LEAK—TRANSMISSION FLUID LEAKS AT RADIATOR—VEHICLES EQUIPPED WITH AUTOMATIC TRANSMISSION AND TRANSMISSION OIL COOLER IN RADIATOR END TANK

Article No. 00-9-1

FORD: 1997-2000 MUSTANG, EXPEDITION, EXPLORER, F-150, F-250 LD
1998-2000 RANGER
1999-2000 SUPER DUTY F SERIES

Figure 1 - Article 00-9-1

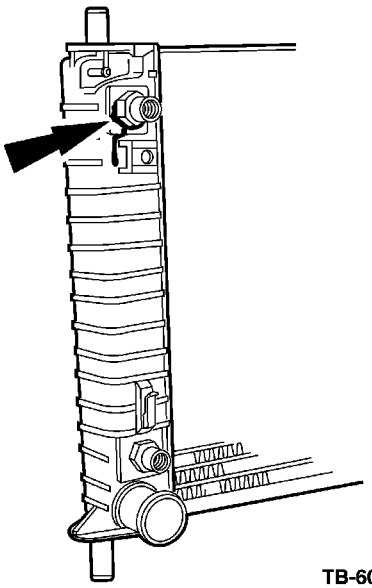
1. Verify that transmission fluid is leaking between the transmission oil cooler and the transmission oil cooler fitting (NOT the transmission cooler line fitting into the transmission oil cooler fitting). Refer to Figure 1.
2. Remove the radiator from the vehicle following Workshop Manual procedure. Place the radiator on a flat surface so that the transmission oil cooler fittings are facing upward. Refer to Figure 2.
3. Clean the area around the transmission oil cooler fitting. This will insure that contaminants do not enter the transmission oil cooler when the transmission oil cooler fittings are removed.

Figure 2 - Article 00-9-1

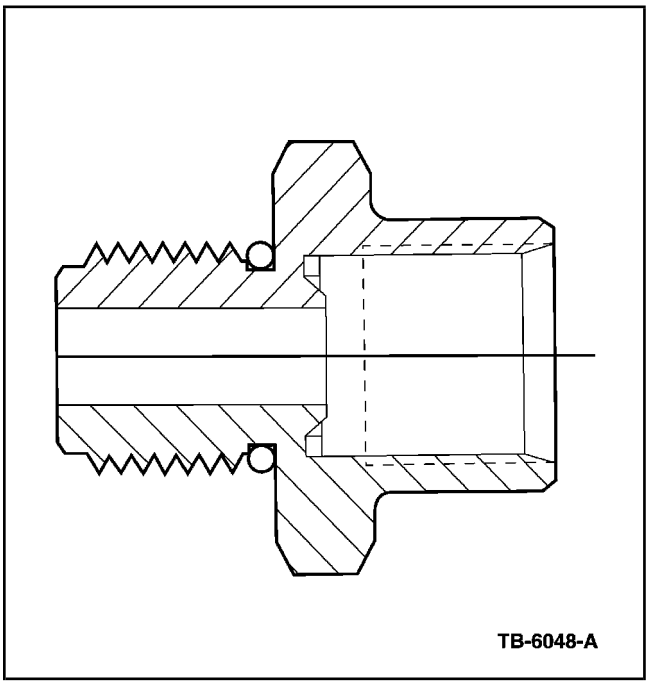
5. Once the fitting is removed from the transmission oil cooler, verify that there is a gasket between the transmission oil cooler and the inside of the radiator tank. If there is no gasket, replace the radiator. If the gasket is in place, continue to Step 6.
6. Inspect the transmission oil cooler fitting threads for damage. If the threads are damaged, replace the radiator. If the threads show no sign of damage, continue to Step 7.
7. Install O-ring W705181-S on the transmission oil cooler fitting. Refer to Figures 2 and 3.

8. Making sure that the gasket between the transmission oil cooler and the inside of the radiator tank is still in place, reinstall the transmission oil cooler fitting. The fitting should be torqued to 38-45 N•m (28-33 lb-ft).
